7/21/21	<span style="color:red">6</span> Added Removal of Existing Delineators
7/14/21	<span style="color:red">4</span> Added Clear & Grub Limits
DATE	REVISION
STATE OF HAWAII DEPARTMENT OF TRANSPORTATION HIGHWAYS DIVISION	
<b>DEMOLITION AND EROSION CONTROL</b>	
<b>INTERSTATE ROUTE H-1 RESURFACING</b>	
Miller Pedestrian Overpass to Kapiolani Interchange	
Federal-Aid Project No. NH-HI-1(279)	
Scale: 1" = 40'	
Date: August 2021	
SHEET No. EC4 OF 23 SHEETS

<b>DEMOLITION AND EROSION CONTROL</b>	
INTERSTATE ROUTE H-1 RESURFACING	
Miller Pedestrian Overpass to Kapiolani Interchange	
Federal-Aid Project No. NH-HI-1(279)	
Scale: 1" = 40'	
Date: August 2021	
SIGNATURE	04/30/22
EXPIRATION DATE OF THE LICENSE	
SHEET No. EC7 OF 23 SHEETS

DEMOLITION AND EROSION CONTROL	
<u>INTERSTATE ROUTE H-1 RESURFACING</u>	
<u>Miller Pedestrian Overpass to Kapiolani Interchange</u>	
Federal-Aid Project No. NH-HI-1(279)	Date: August 2021
Scale: 1" = 40'	
SHEET No. EC8 OF 23 SHEETS

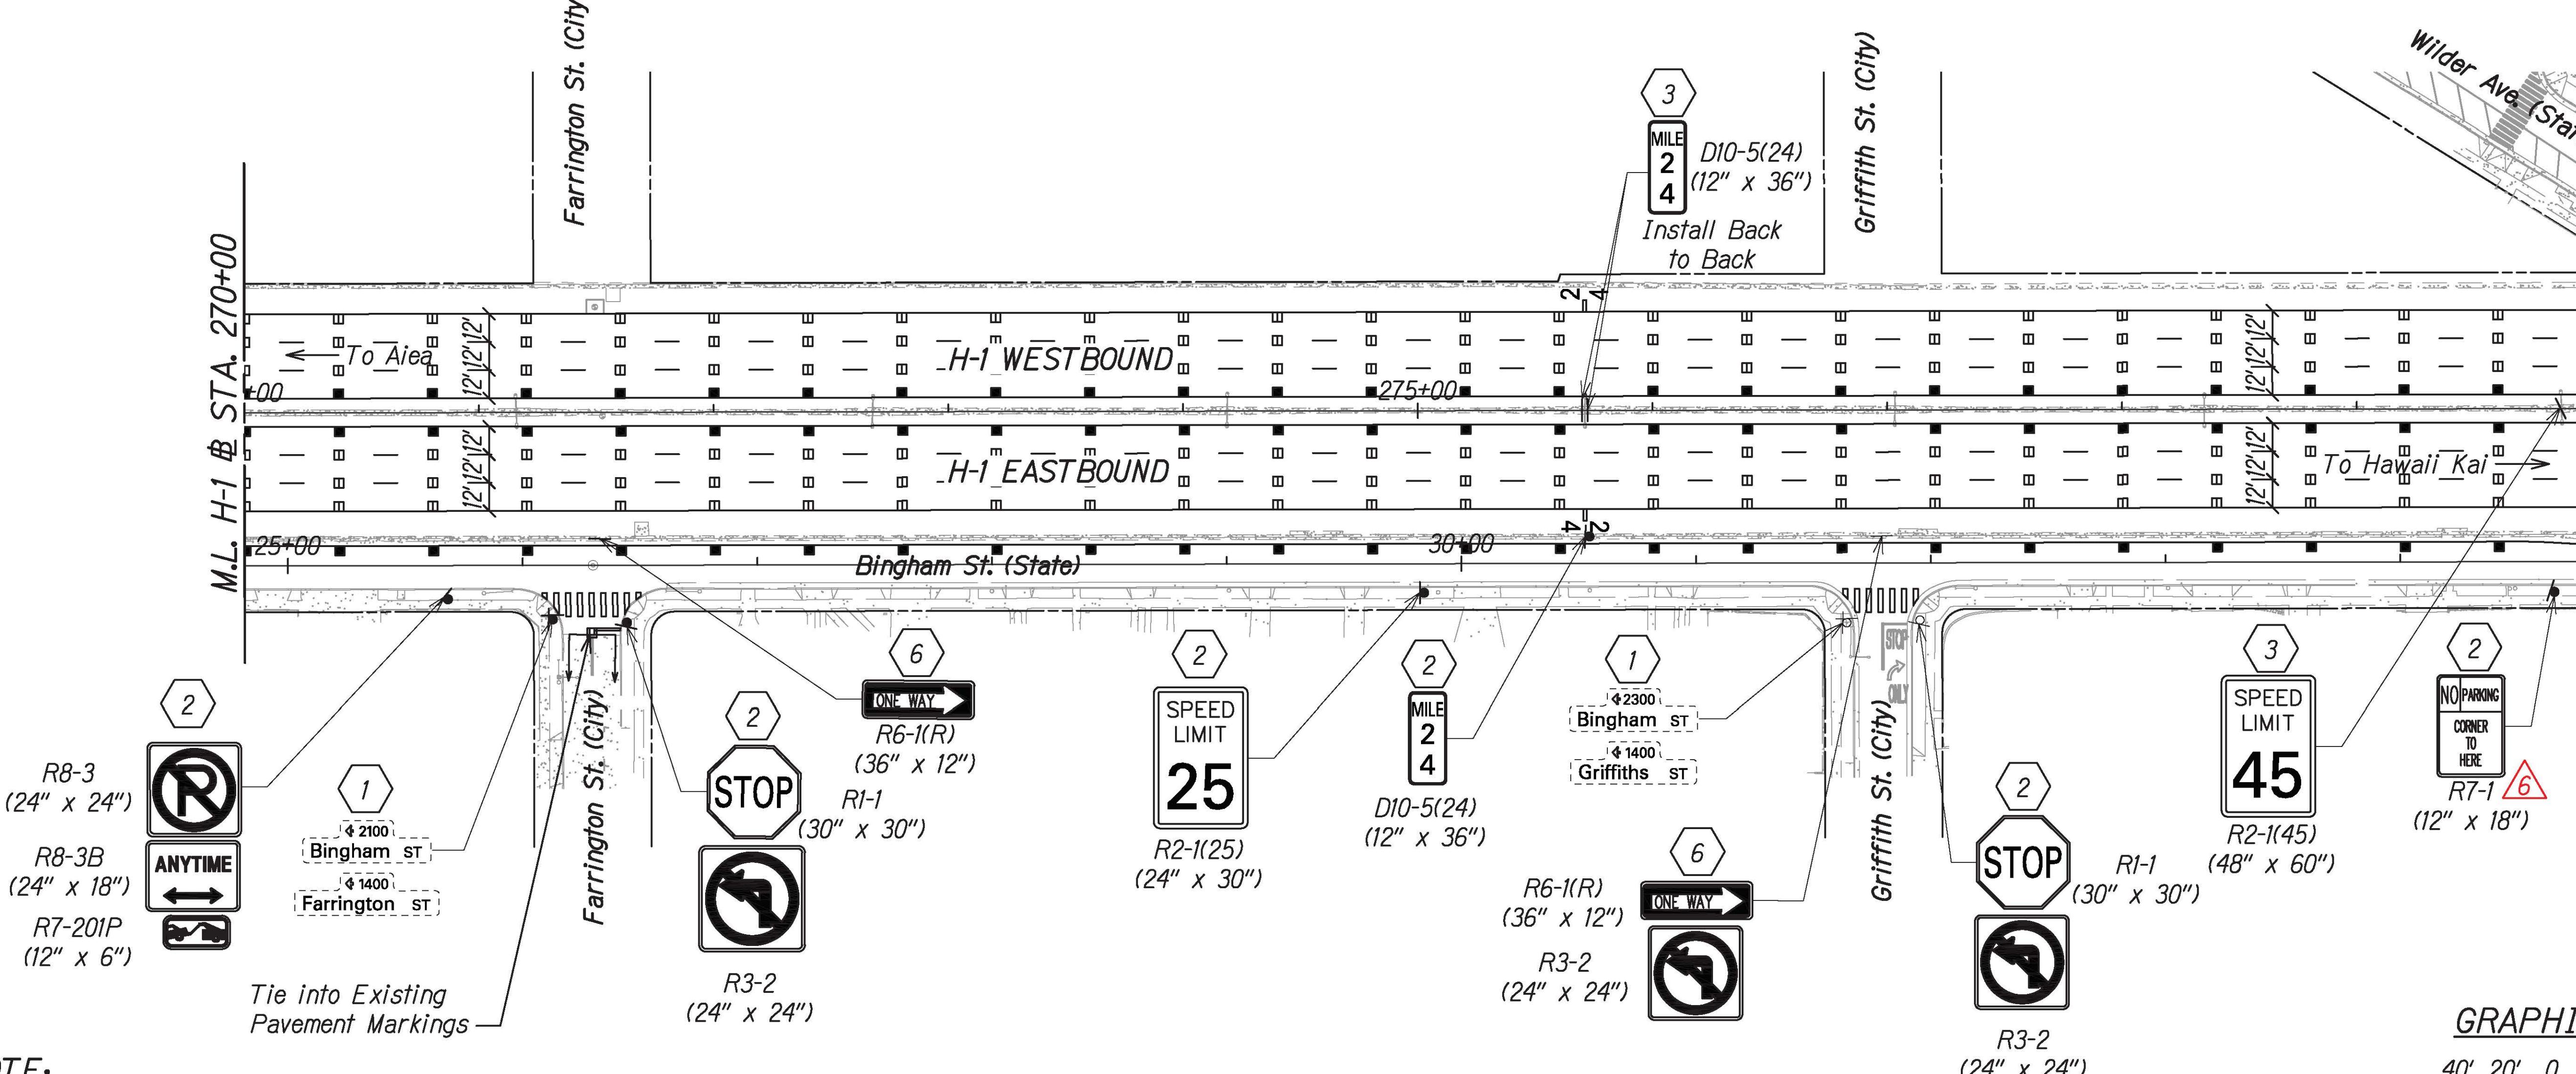
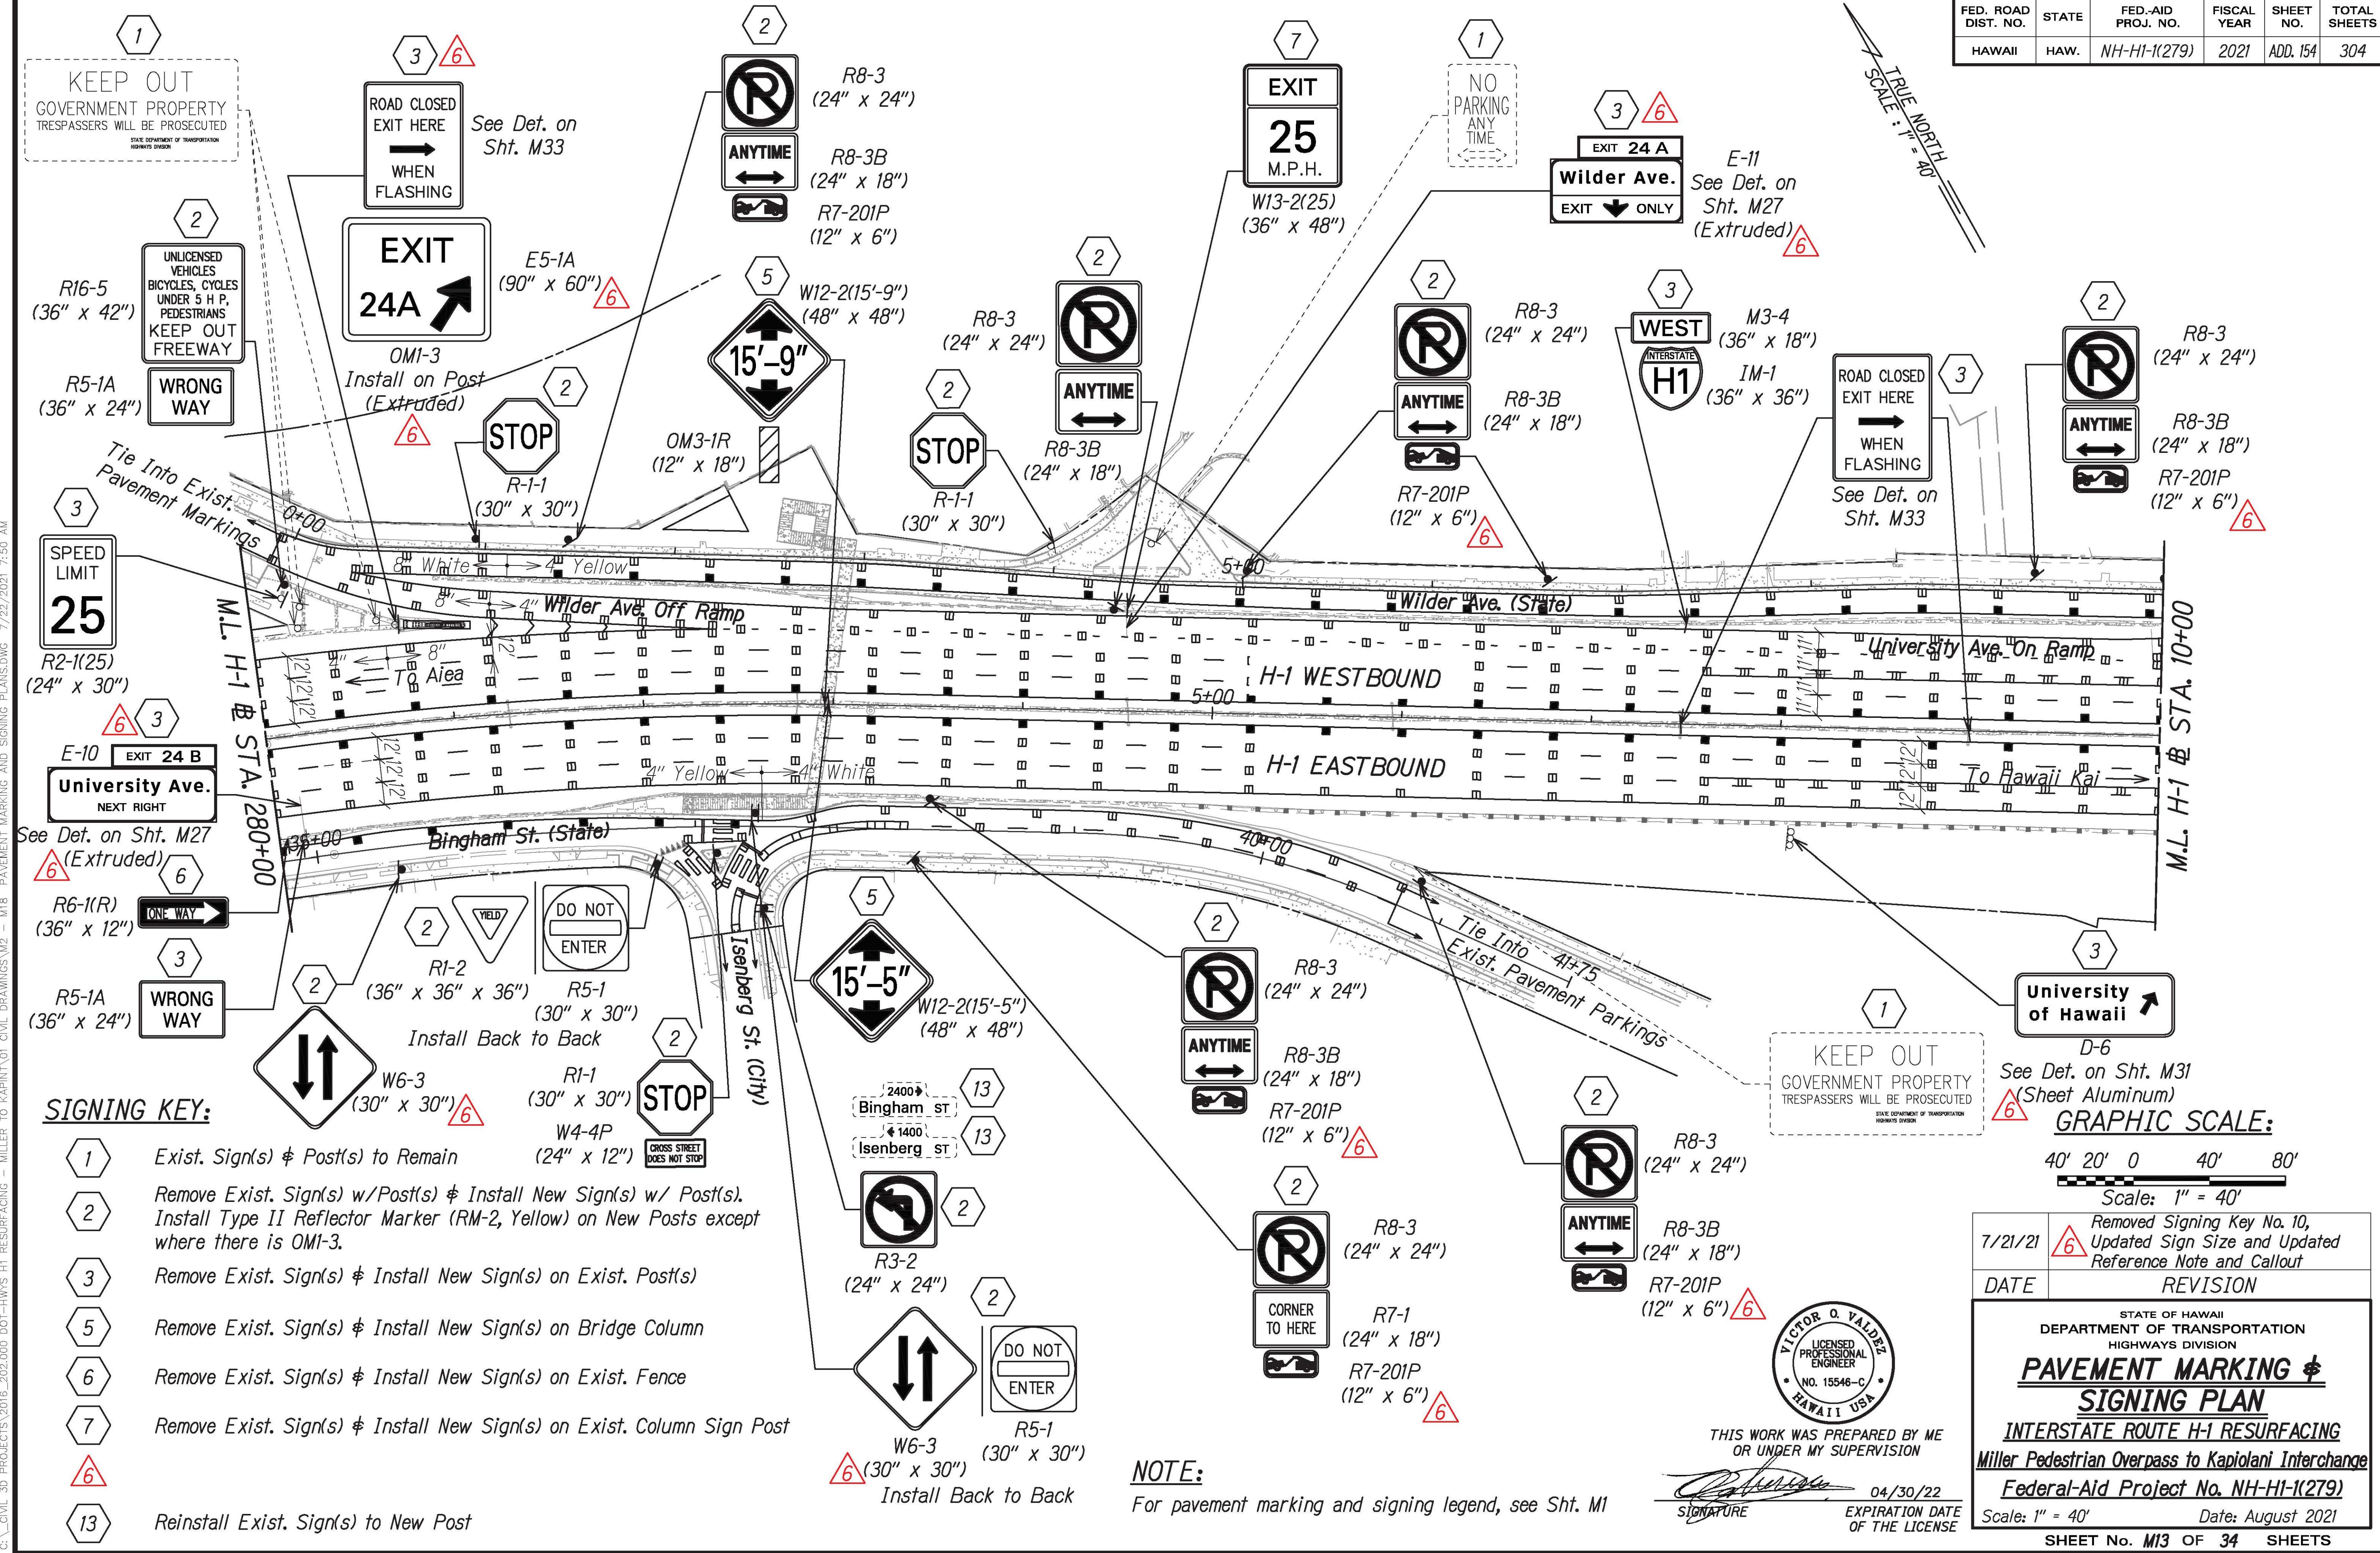
7/21/21	<span style="color: red;">6</span>	Updated Sign Description
DATE	REVISION	
STATE OF HAWAII DEPARTMENT OF TRANSPORTATION HIGHWAYS DIVISION		
<b>PAVEMENT MARKING &amp; SIGNING PLAN</b>		
INTERSTATE ROUTE H-1 RESURFACING		
Miller Pedestrian Overpass to Kapiolani Interchange		
Federal-Aid Project No. NH-HI-1(279)		
Scale: 1" = 40'		
Date: August 2021		
SHEET No. M12 OF 34 SHEETS

SHEET NO. M16 OF 34 SHEETS

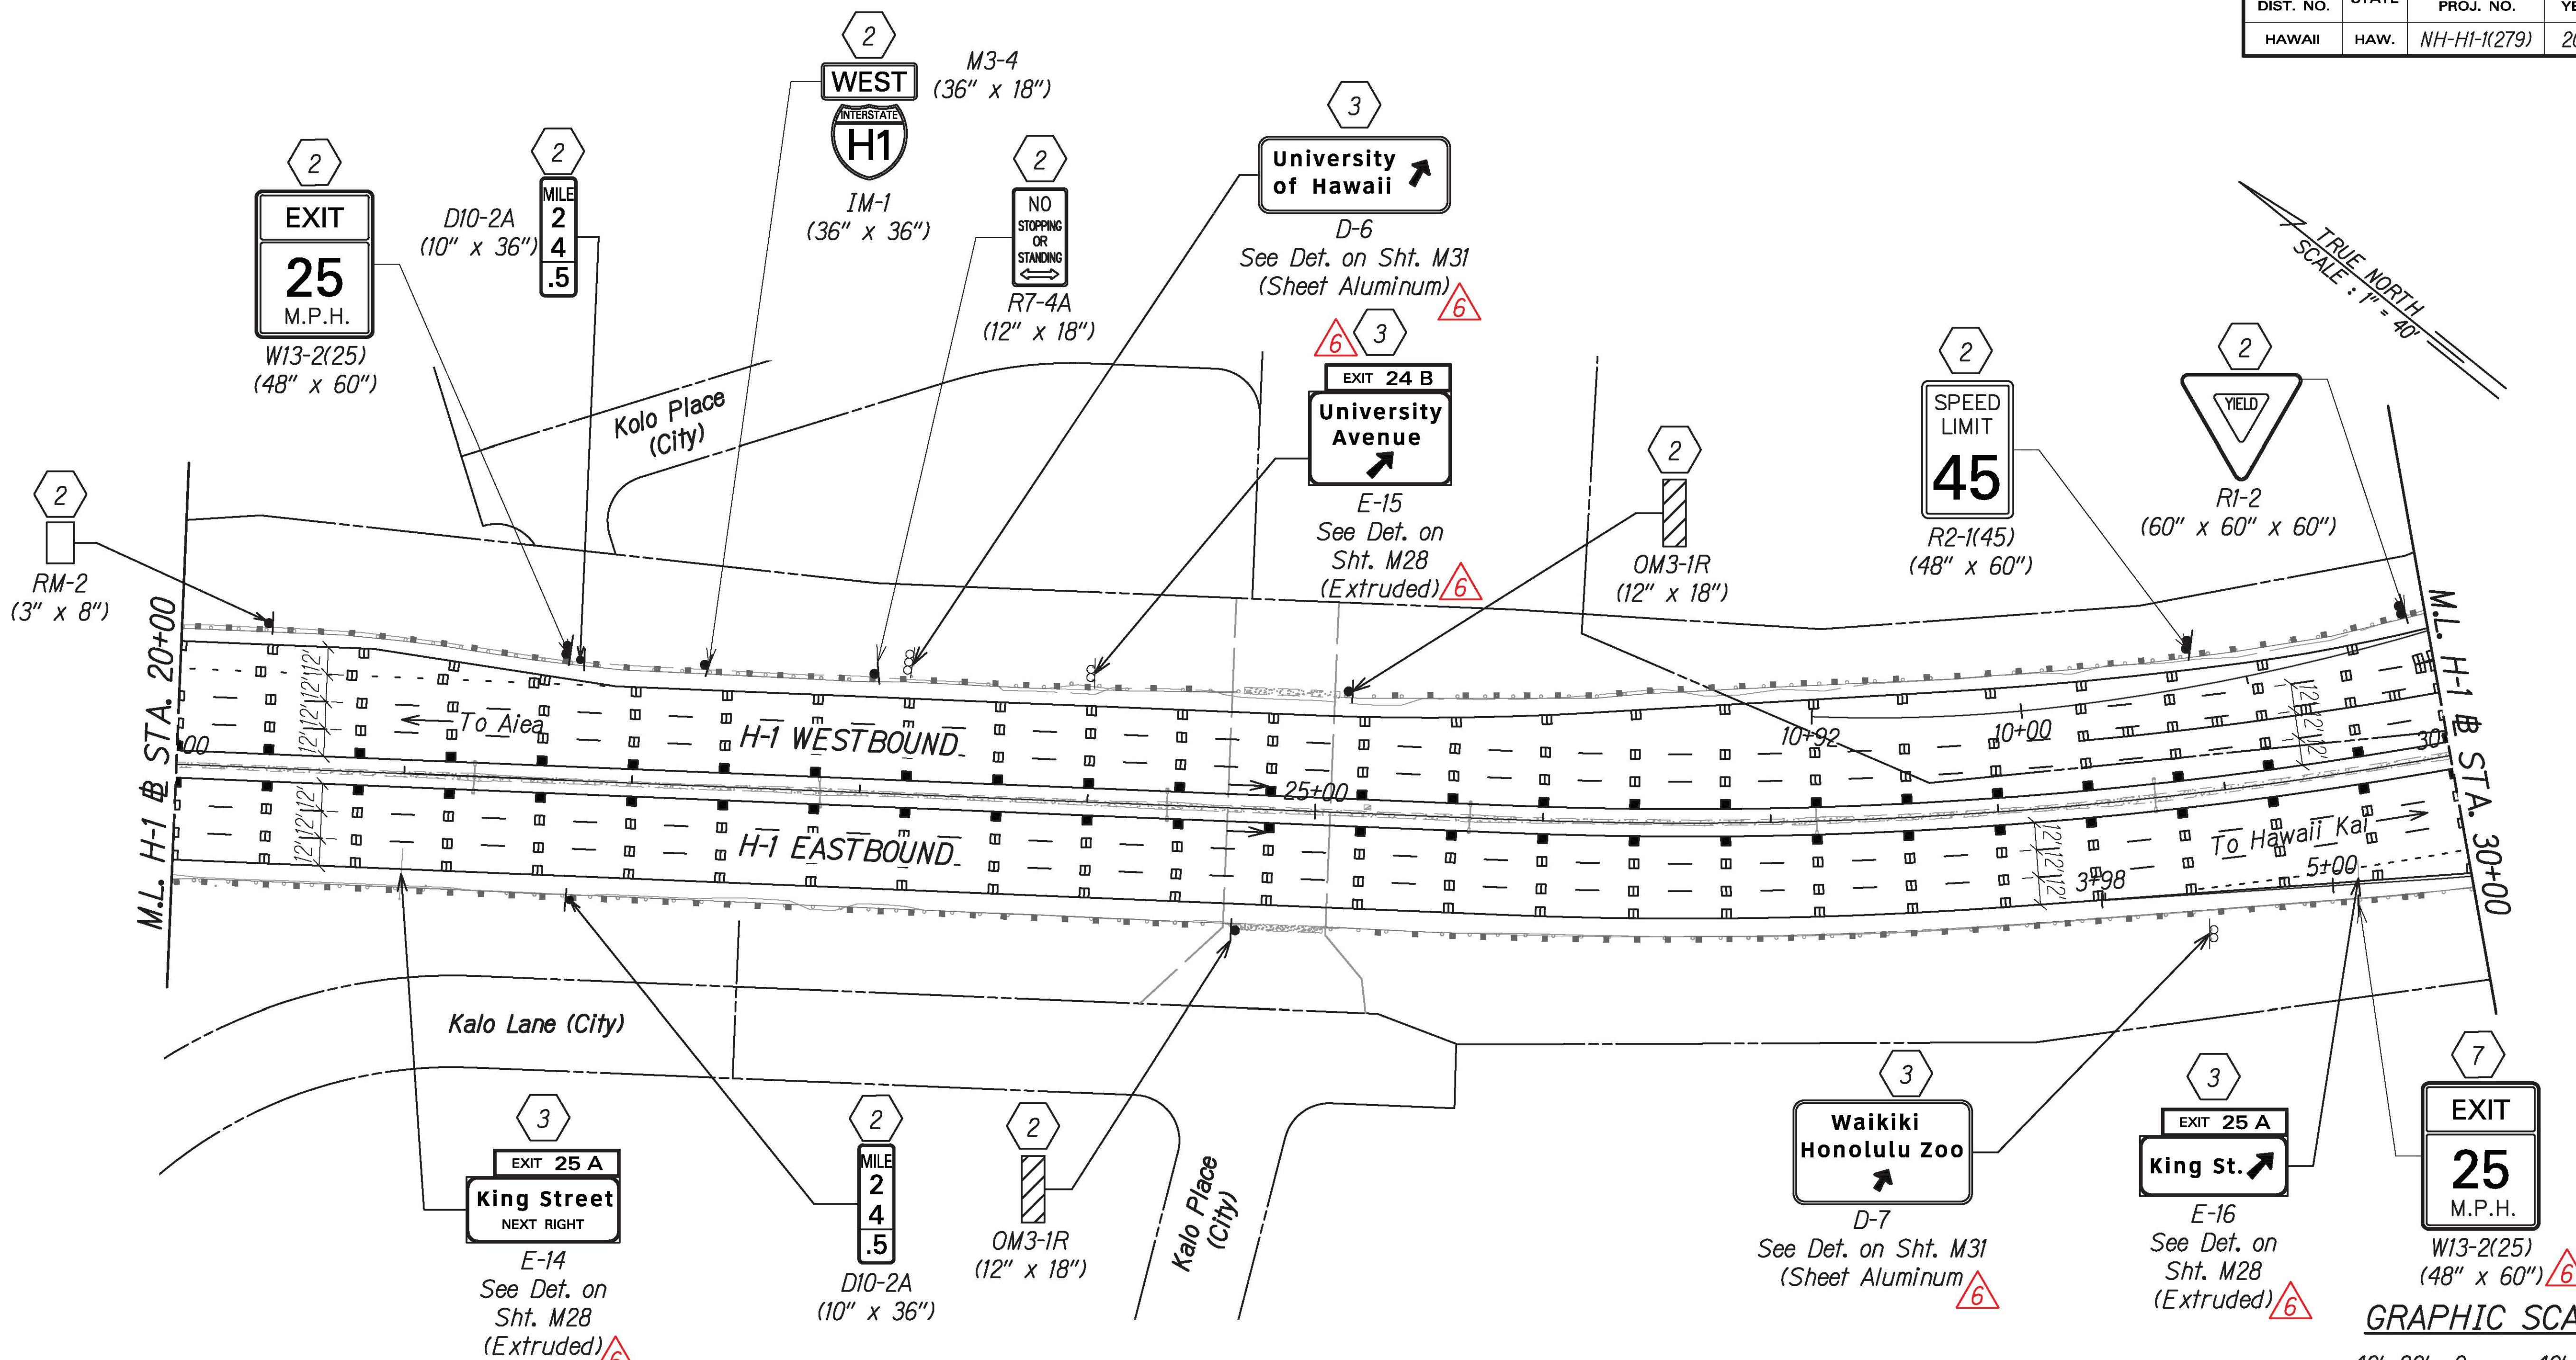
7/21/21	Removed Signing Key No. 10, Updated Sign Size and Updated Reference Note and Callout (6)
DATE	REVISION
STATE OF HAWAII DEPARTMENT OF TRANSPORTATION HIGHWAYS DIVISION <b>PAVEMENT MARKING &amp; SIGNING PLAN</b> INTERSTATE ROUTE H-1 RESURFACING Miller Pedestrian Overpass to Kapiolani Interchange Federal-Aid Project No. NH-HI-1(279)	
Scale: 1" = 40'	
Date: August 2021
